**Mountain Valley Pipeline, LLC
Mountain Valley Pipeline Project
Docket No. CP16-10-000**

**Response to Post-Draft Environmental Impact Statement
Environmental Information Request #2 Issued March 20, 2017**

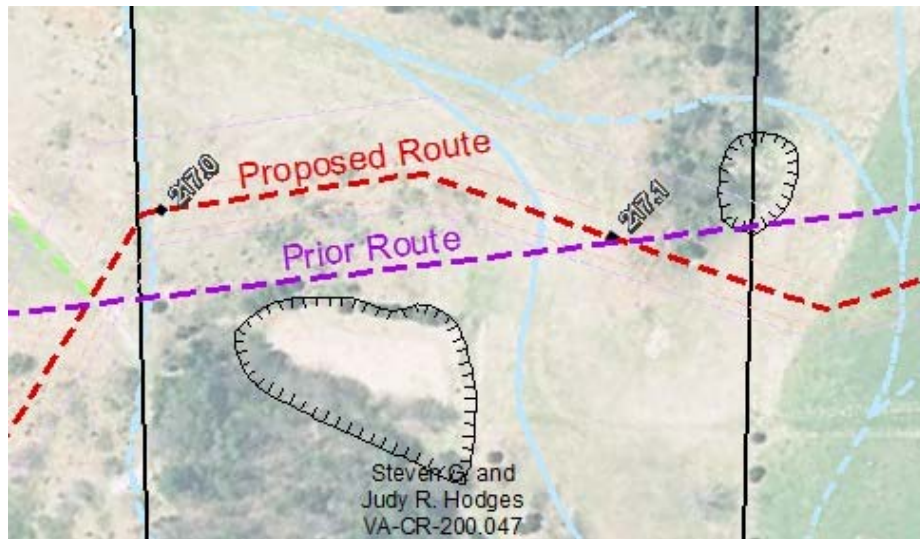
Based on field visit observations by the Mountain Valley Karst Specialist Team, the Project alignment was adjusted on the Hodges property in

October 2016 to increase the distance between the alignment and the two sinkholes Mr. Hodges identified in his December 2016 letter. This is demonstrated in the snippet below from the relevant alignment sheet. This alignment adjustment provides additional separation buffer from the sinkholes.

The sinkhole referenced by Mr. Hodges at MP 217.13 is a small sink with fieldstone-filled bottom. This configuration of sinkhole is commonly observed throughout the region. Observations and mapping by the Mountain Valley Karst Specialist Team (KST) (as part of the Karst Hazards Assessment) indicated the contributing watershed to this sinkhole is approximately 5.2 acres. Since there was no ponded water observed in the sinkhole during the September 2, 2015 KST field observation site visit for the Karst Hazards Assessment (on which Mr. Hodges accompanied the KST), it is clear that this sinkhole ultimately drains precipitation and overland flow into the subsurface during precipitation events. This is a normal and fully expected process in karst terrain, and the observation presented by Mr. Hodges in his December 2016 letter merely reflects reasonably expected conditions in karst terrain. Mountain Valley, aware of karst processes, has prepared a Karst Mitigation Plan and an Erosion and Sediment Control Plan with karst-specific BMPs in order to avoid or mitigate sinkholes and other karst features and to prevent the uncontrolled release of surface water from the limit of disturbance during construction. These measures will protect the karst features and the underlying karst hydrogeologic system.
